Solar Farm at Flixborough, DN15 8SG

Surface Water Drainage Strategy – Discharge of Planning Condition 10

Planning Application Reference: PA/2015/0434
Appeal Reference: APP/Y2003/W/16/3142032

23rd January 2017 V1

Fig 2 Proposed layout highlighting swale location as accepted, and changes in sensitive equipment location and swale location

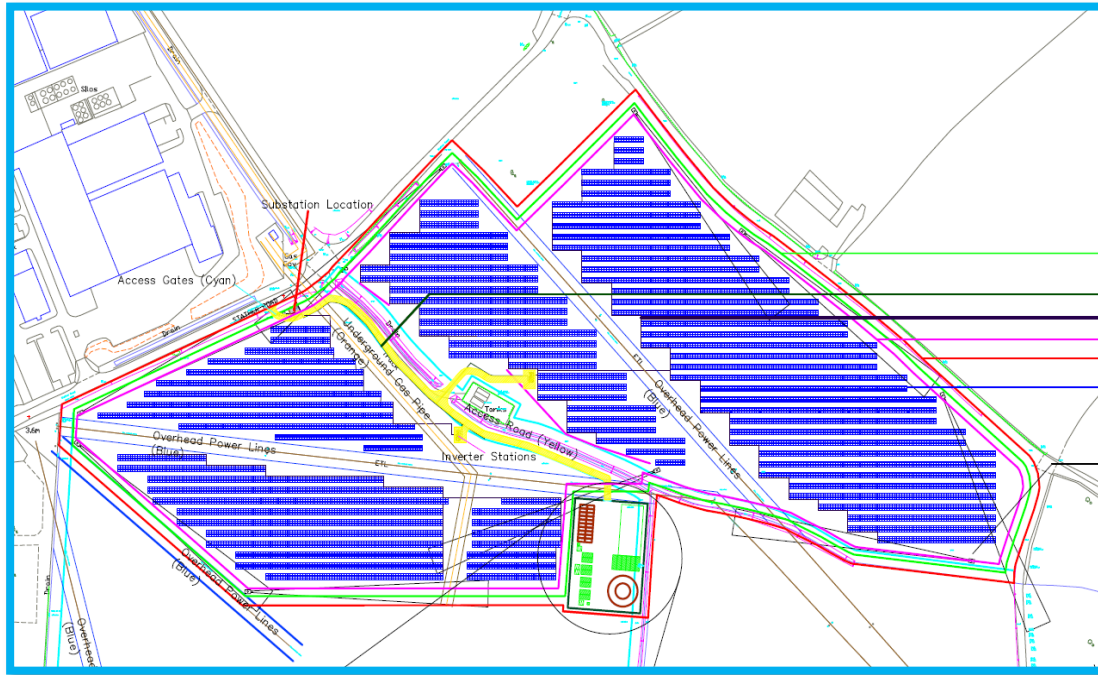
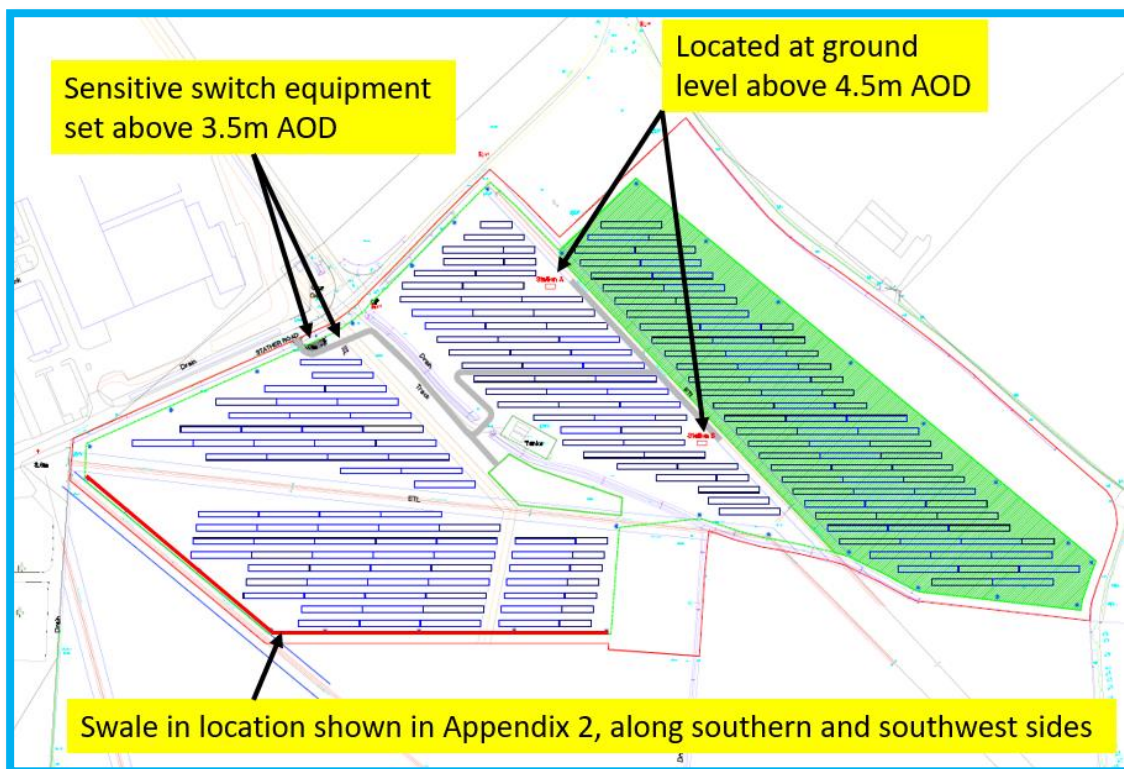
- The extent of solar arrays is reduced, as can be seen by comparing the plans below
- The transformers/inverters have been located on the higher ground to the northeast of the site, above the 3.5m contour

- The switchgear and associated equipment is in buildings near the site entrance, but the sensitive equipment will be raised above 3.5m AOD.

Fig 4 Indicative cross section of 200mm deep furrow, with 200mm high ridge, as accepted previously. Side slopes will be typically 1 in 3, but can vary at pinch points, provided depth and height is maintained.

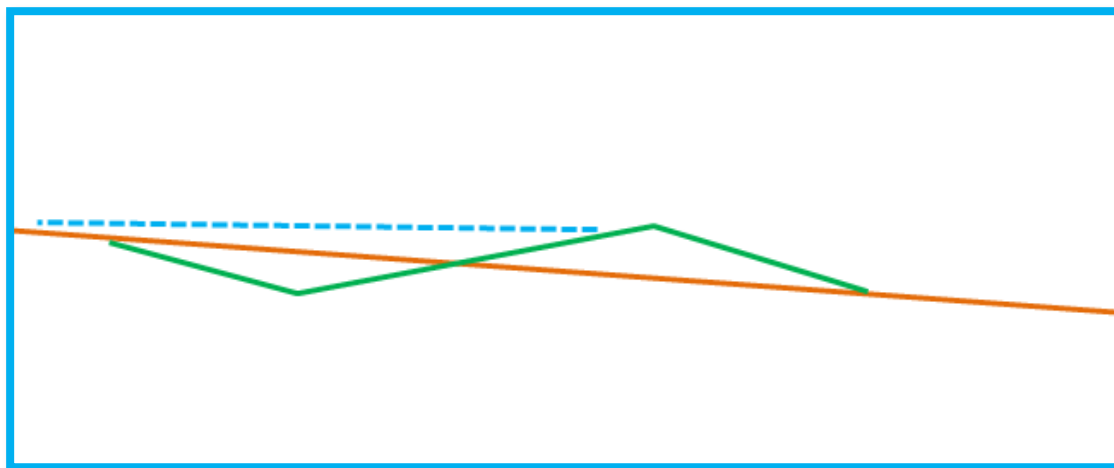
1. Downstream land still has the potential to suffer from a level of flooding due to drainage overflow. The installation of a linear drainage system (SWALE) to capture surface water run-off should be considered. Further advice can be sought by contacting the Drainage Team on 01724 297522. Any advice offered by the Drainage Team should be acted upon.

The proposed swale will be constructed as previously accepted
